SUBJECT: Supplement to the Application for Certification
Rio Mesa Solar Energy Generating Facility (11-AFC-4)

Response to Data Adequacy Review of the APPLICATION FOR CERTIFICATION for the Rio Mesa Solar Electric Generating Facility

(11-AFC-04)

Response to Data Adequacy Review

BSII (Ltd.)	OWNER DRAWING NO.		
	Figure 2-11		
	JOB NO.	DRAWING NO.	REV.
	25670	009-EZ-3590-00001	A

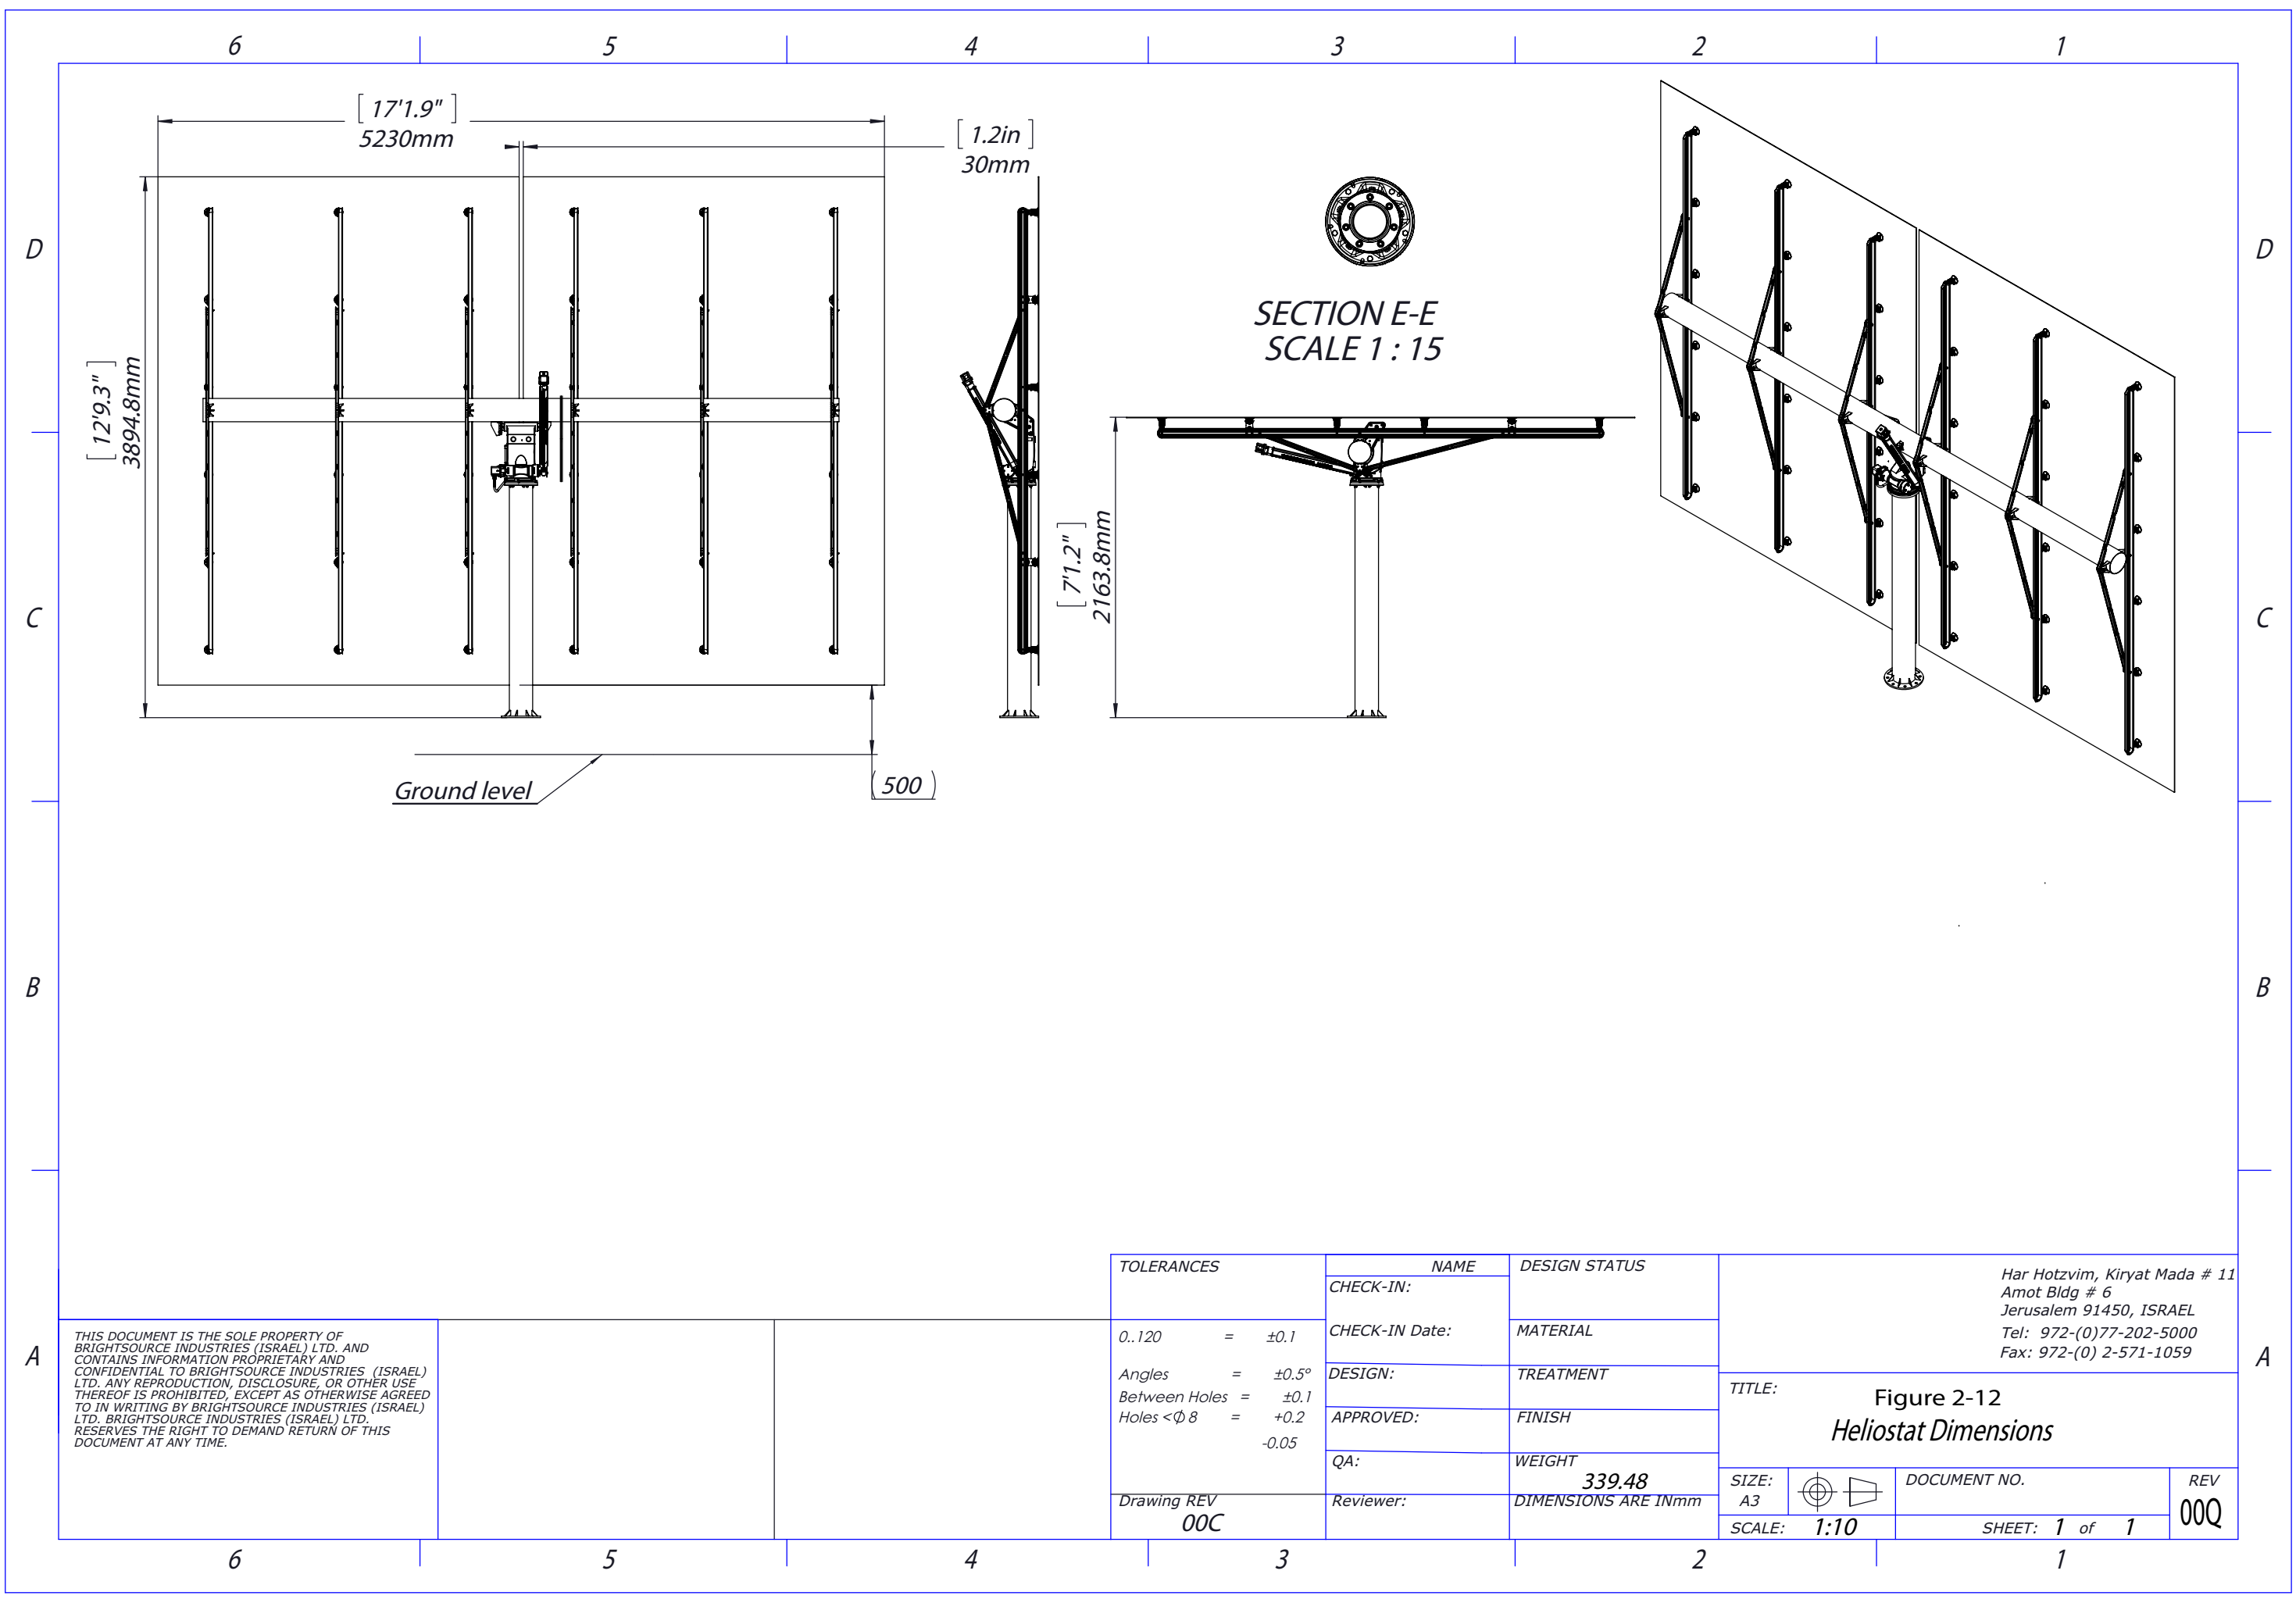
Provide scaled plans and elevation drawings (all four sides) of the power plant and all related facilities (e.g. power block area with associated buildings and facilities, common area with associated buildings and facilities, a heliostat, etc.).

Response: Attached are the following scaled plans and elevation drawings representing the power plant and all related facilities.
